Agenda Item # 5

SUB-003208-2025

Foo Properties Airport Boulevard West Subdivision

- Subdivision approval to create two (2) legal lots of record from two (2) existing legal lots and one (1) metes-and-bounds parcel.

DETAIL SITE PLAN

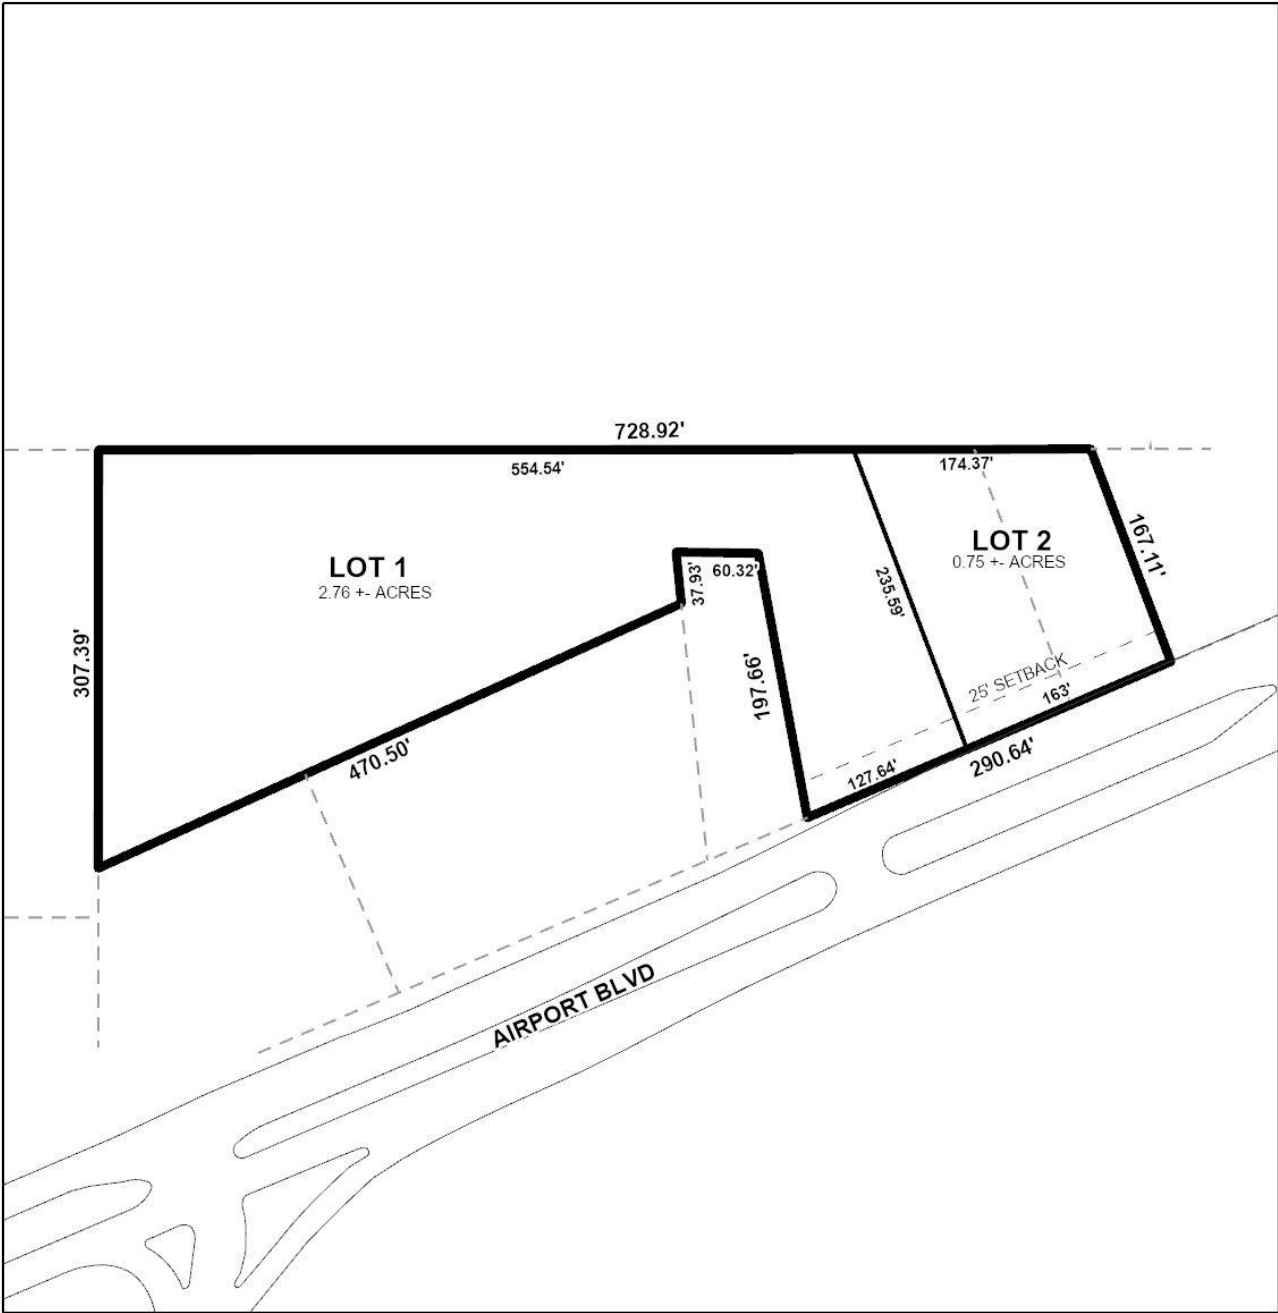
- B. Provide a different line type or weight (i.e. thicker) that differentiates the proposed subdivision boundary from the other lines shown on the drawing.

- C. Provide and label the monument set or found at each subdivision corner.
- D. Add a signature block for the Owner, Notary Public, Planning Commission, Traffic Engineer, and City Engineer.

- E. Label Airport Blvd. and indicate the public ROW width and distance from LOT 1 & 2 to the centerline.
- F. Add a note to the SUBDIVISION PLAT stating that as shown on the 1984 aerial photo LOTS 1 and 2 will receive historical credit of existing (1984) impervious area towards stormwater detention requirement per Mobile City Code, Chapter 17, Storm Water Management and Flood Control) as follows: LOT 1 – 3,000 sf AND LOT 2 – 17,000 sf.

Both Lot 1 and Lot 2 front Airport Boulevard, a Principal Arterial street requiring a minimum 100-foot right-of-way width per the Major Street Plan. The preliminary plat does not label Airport Boulevard or illustrate a compliant right-of-way. If approved, the Final Plat must be revised to label Airport Boulevard and either illustrate a compliant right-of-way width or dedication sufficient to provide 50 feet from the centerline of Airport Boulevard.

It should be noted that as proposed, Lot 1 is an irregularly shaped lot. Section 6.C.1. of the Subdivision Regulations requires the size, width, depth, shape, and orientation of all proposed lots be "compatible and appropriate" to the location of the Subdivision and the type of development and use contemplated. Staff was not provided any information regarding the contemplated use or future development, though existing development has been for commercial use. While the proposed layout of Lot 1 is non-standard to commercial development there appear to be other irregularly shaped lots within the area. As such, if approved, a waiver of Section 6.C.1. may be appropriate.

It should be noted that per aerial imagery, Lot 1 & 2 and the abutting property to the North may share a common lot line through an existing building, and through part of an existing parking lot. If so, the resulting setbacks of the building on each lot should not be an issue considering Section 64-2-14.E. of the UDC allows for either a zero-foot, or a five (5)-foot side and rear yard setback for lots in the B-3 zoning district; however, shared access to the parking lot should be facilitated via the appropriate legal instrument (e.g. ingress/egress easement, reciprocal easement, etc.), which has not been presented to Staff, and is not illustrated on the preliminary plat.
